Alternatives to Energize Eastside

Response to Draft EIS

February 15, 2016

Prepared for:
CENSE

Figure 3: PSE 2015 IRP *Figure 5-21: Electric Peak Demand Forecast before DSR 2015 IRP Base Scenario versus 2013 IRP Base Scenario Hourly Annual Peak (23 Degrees, MW)*

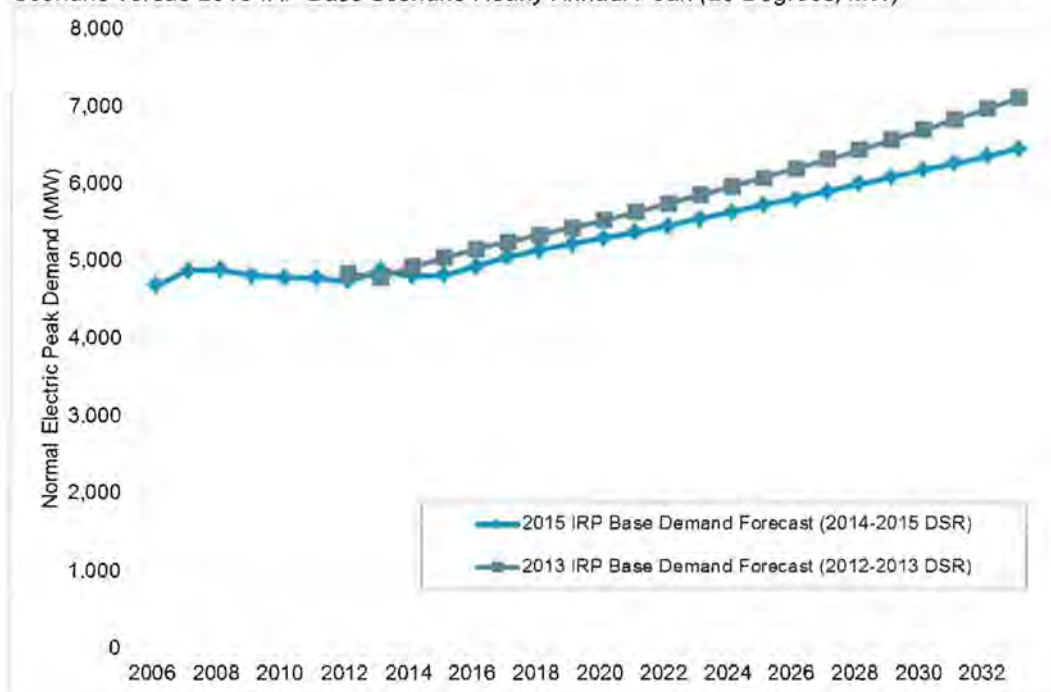
Figure 2 below shows how peak load is historically flat, then suddenly takes off in the future. You'll find this to be true with PSE's previous peak load forecasts. I understand that forecasts are, by their nature are wrong, but PSE has a habit of overestimating peak load.

PSE's 2011 IRP had peak forecasts rising from 2011 forward.³ This is not happening.

Figure 5-27: Electric Peak Forecasts by County (MW), after applying 2013 IRP DSR

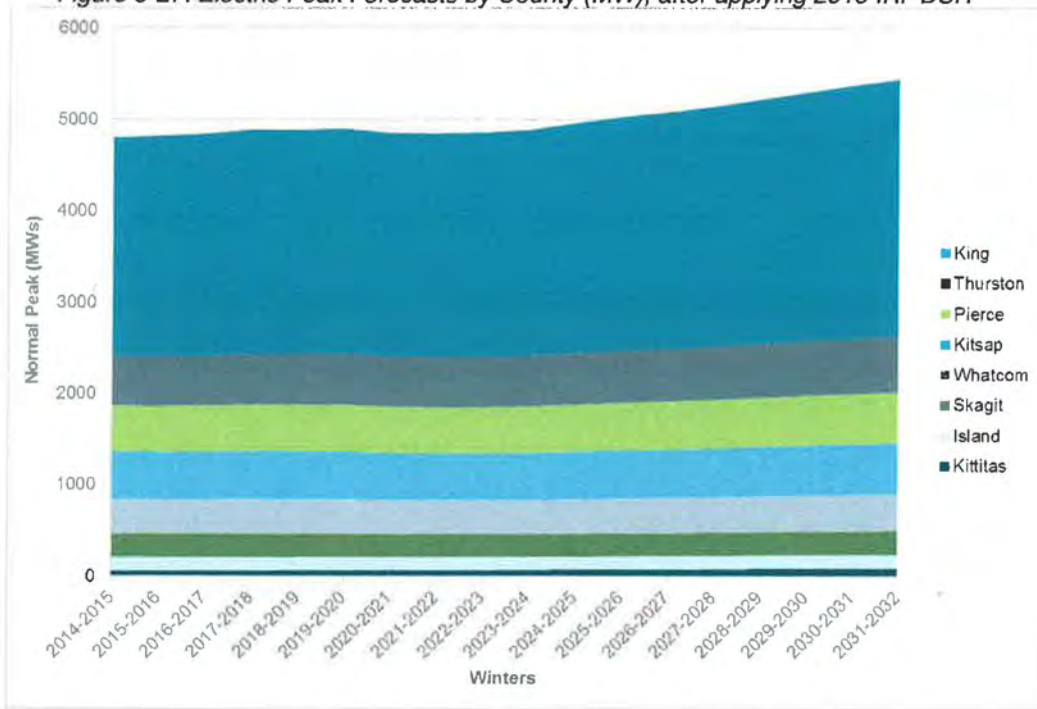
Notice in Figure 5-27 from PSE's 2015 IRP, the peak demand does not begin to increase until 2024.
